Certificate
DEC 02 2005
of Correction

UNITED STATES PATENT AND TRADEMARK OFFICE
CERTIFICATE OF CORRECTION

PATENT NO: 6,919,880
ISSUED: July 19, 2005
INVENTOR(S): Gerald Morrison and David Holmgren

FIG. 2

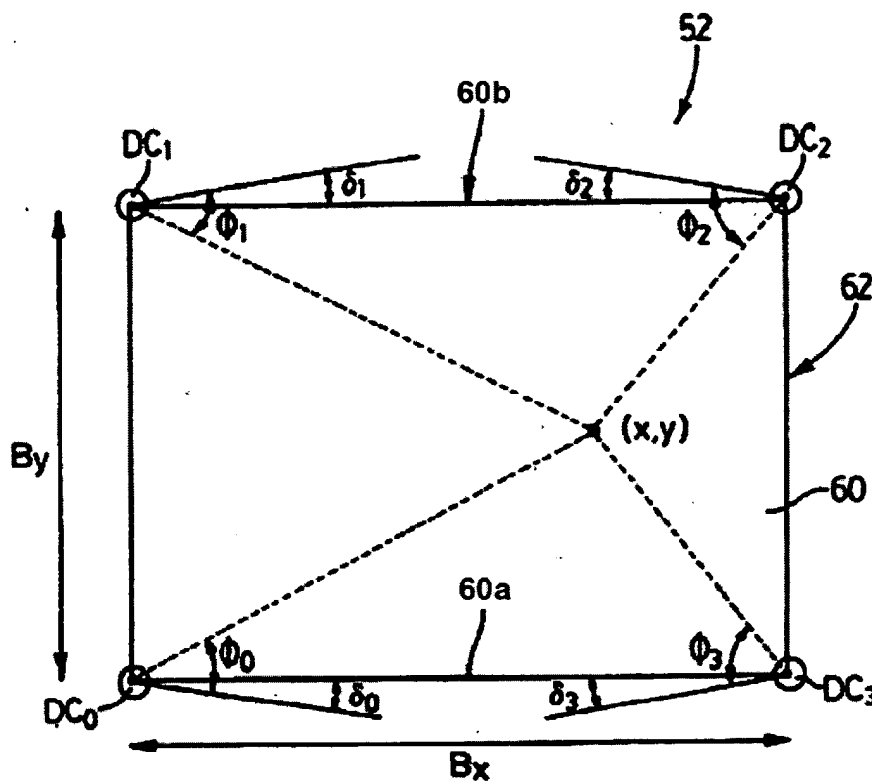
In the Drawings, Figure 2, "62a" should read -60a--.

In the Drawings, Figure 2, "62b" should read -60b--.

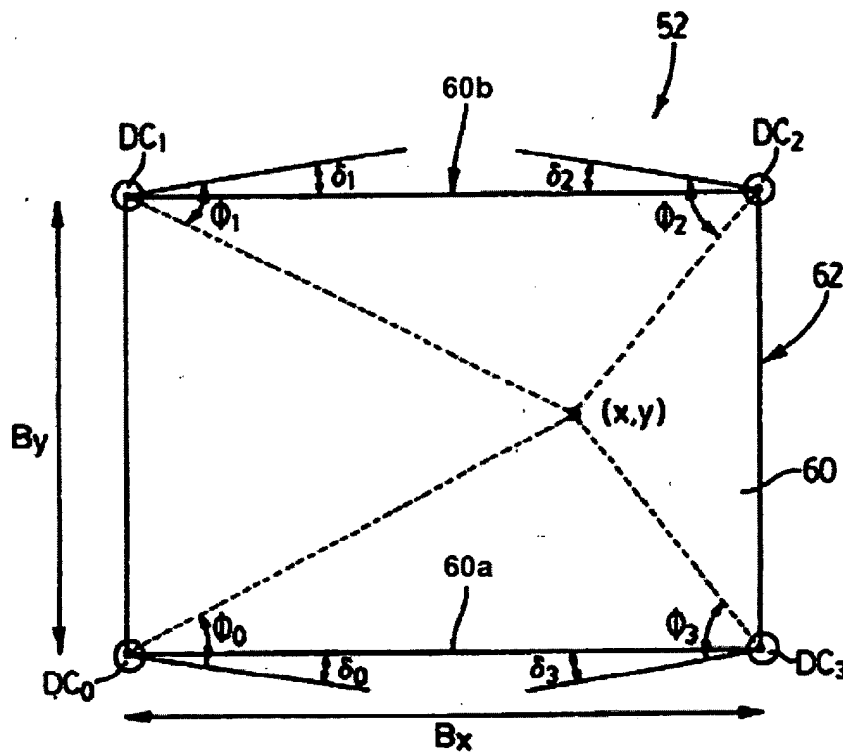
On the Cover Page, in the Representative Drawing, "62 a" should read --60a--.
On the Cover Page, in the Representative Drawing, "62 b" should read --60b--.

FIG. 2

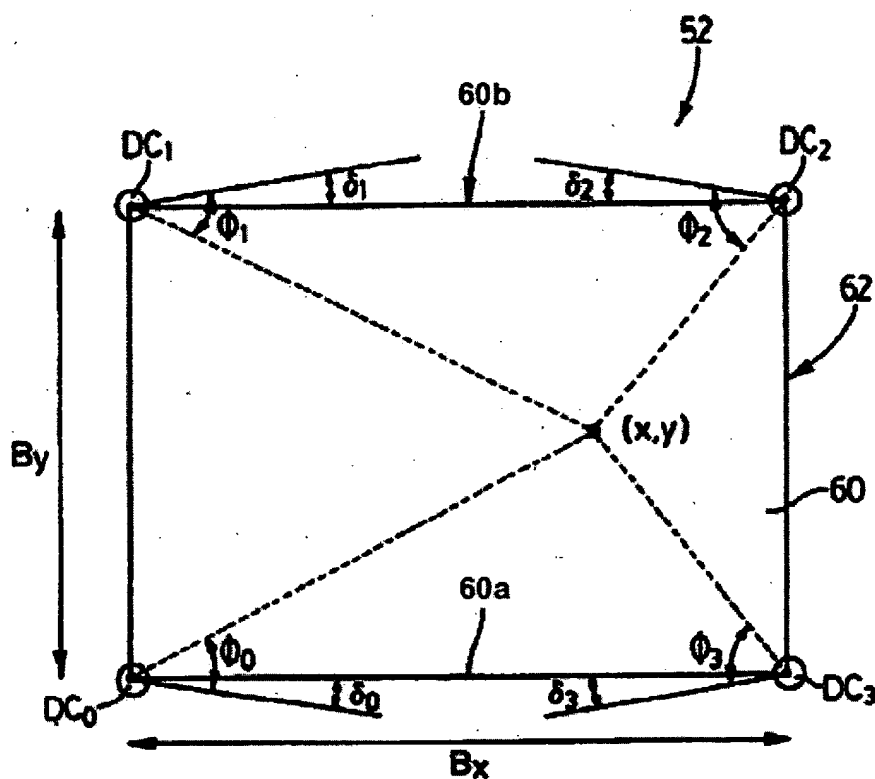
In the Drawings, Figure 2, "62a" should read -60a--.

In the Drawings, Figure 2, "62b" should read -60b--.

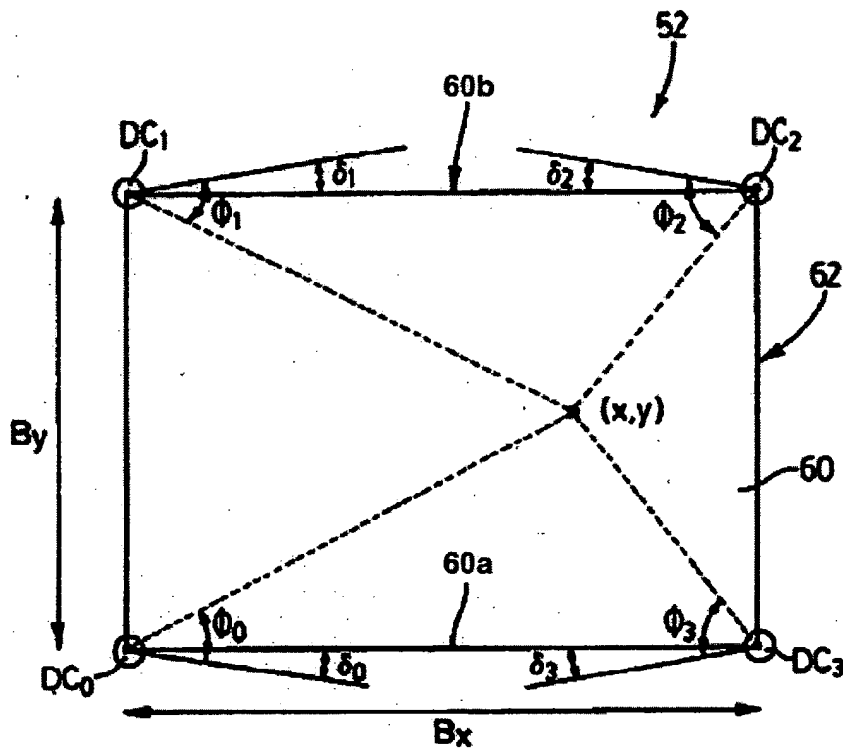
On the Cover Page, in the Representative Drawing, "62 a" should read --60a--.

On the Cover Page, in the Representative Drawing, "62 b" should read --60b--.
